Regulation No. 13-H (Passenger Car Braking)

Proposal for introducing requirements for Brake Assist Systems into Regulation 13H.

The text reproduced below was prepared by the expert from the European Commission with the aim of introducing requirements for Brake Assist Systems (where mandated by Contracting Parties) into Regulation 13H. The text is based on Supplement 7 of Regulation 13H (as adopted at the 146th session of WP29) and document GRRF/2008/15 as amended at the 64th session of GRRF.

Figure 1a: Pedal force characteristic needed in order to achieve maximum deceleration with category "A" BAS

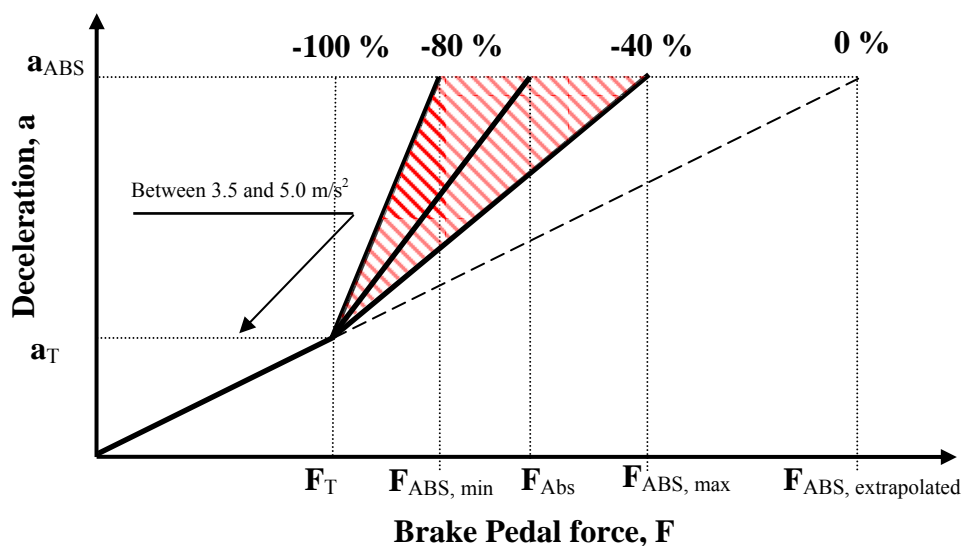
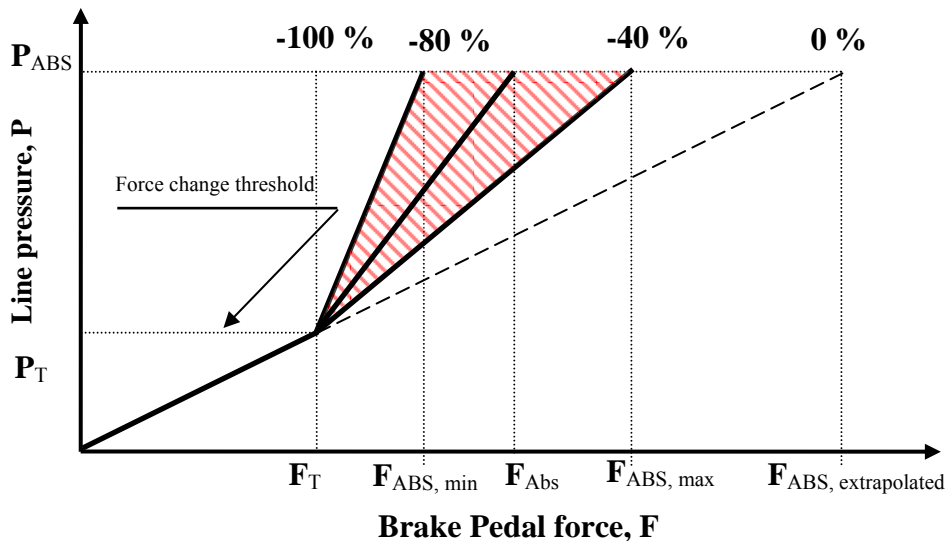
3.2.3. F_T and a_T are threshold force and threshold deceleration as shown in Figure 1. The values of F_T and a_T shall be supplied to the Technical Service at the time of submission of the type-approval application. The value of a_T shall be between 3.5 m/s^2 and 5.0 m/s^2 .

3.2.4. A straight line is drawn from the origin through the point F_T, a_T (as shown in Figure 1a). The value of brake pedal force "F", at the point of intersection between this line and a horizontal line defined by $a=a_{ABS}$, is defined as $F_{ABS, \text{ extrapolated}}$.

- 3.2.5.2. The threshold pressure P_T shall be stated by the manufacturer and correspond to a deceleration in the range of 2.5 - 4.5 m/s².
- 3.2.5.3. Figure 1b shall be constructed in the manner set out in paragraph 3.2.4., but using line pressure measurements to define the parameters set out in paragraph 3.2.5. above where:

$$F_{ABS,extrapolated} = \frac{F_T \cdot a_{ABS}}{a_T}$$

$$F_{ABS,extrapolated} = \frac{F_T \cdot P_{ABS}}{P_T}$$

Figure 2: Example of test 2 of a category "B" BAS system

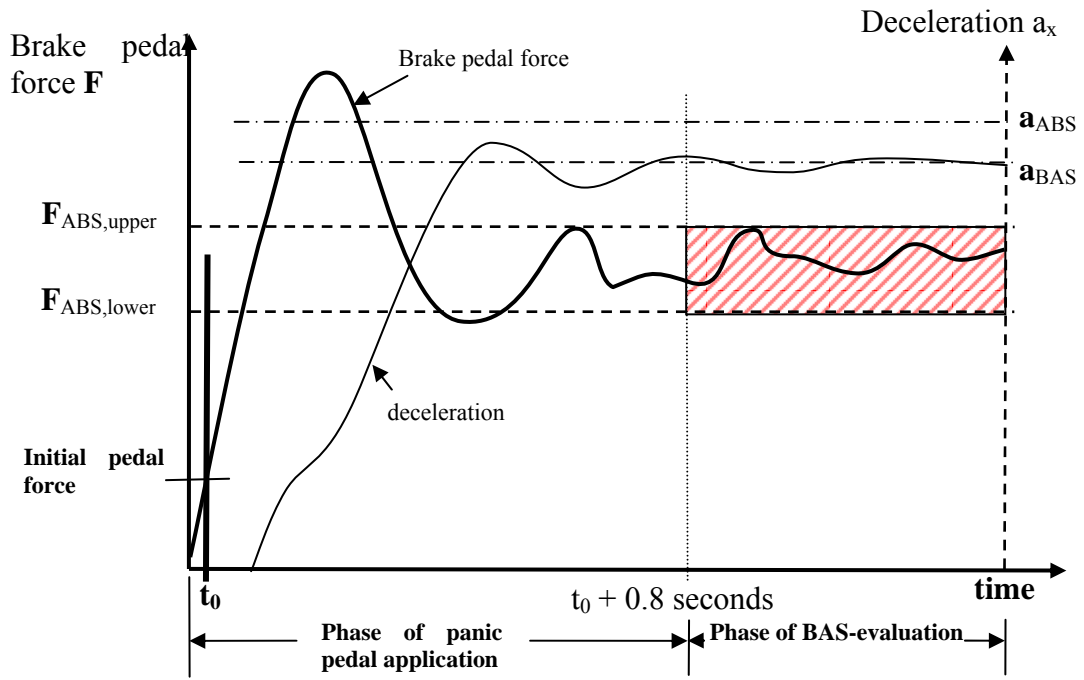
The vehicle shall be driven in a straight line at the test speed specified in paragraph 2.4. above. The driver shall apply the brake pedal quickly according to Figure 2, simulating emergency braking so that BAS is activated and ABS is fully cycling.

After $t = t_0 + 0.8$ s and until the vehicle has slowed down to a speed of 15 km/h, the brake pedal force shall be maintained in a corridor between $F_{ABS, upper}$ and $F_{ABS, lower}$. Where $F_{ABS, upper}$ is $0.7 F_{ABS}$ and $F_{ABS, lower}$ is $0.5 F_{ABS}$.

The presence of BAS 'B' is proven if a mean deceleration of at least $0.85 \cdot a_{ABS}$ is maintained from the time when $t = t_0 + 0.8$ s to the time when the vehicle speed has been reduced to 15 km/h.

Figure 3: Deceleration corridor for determination of F_{ABS} and a_{ABS}

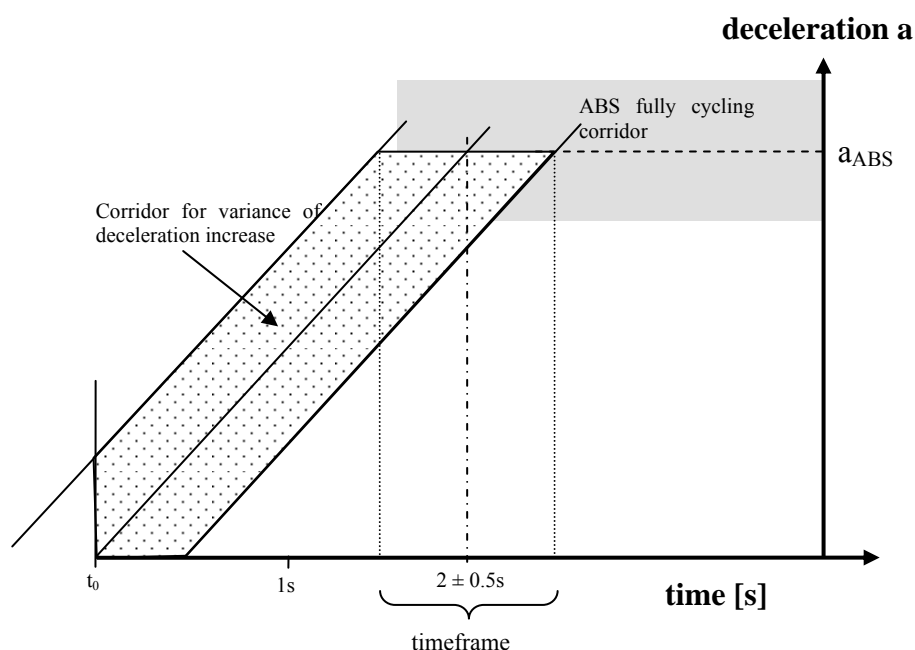
- 1.2. The brake pedal shall be applied slowly (without activating the BAS in the case of category B or category C systems) providing a constant increase of deceleration until ABS is fully cycling (Figure 3).

- 1.3. The full deceleration must be reached within the timeframe of 2.0 ± 0.5 s. The deceleration curve, recorded against time, must be within a corridor of ± 0.5 s around the centre line of the deceleration curve corridor. The example in Figure 3 has its origin at the time t_0 crossing the a_{ABS} line at 2 seconds. Once full deceleration has been achieved the pedal travel S_p shall not be decreased for at least 1 s. The time of full activation of the ABS system is defined as the time when pedal force F_{ABS} is achieved. The measurement shall be within the corridor for variance of deceleration increase (see Figure 3).
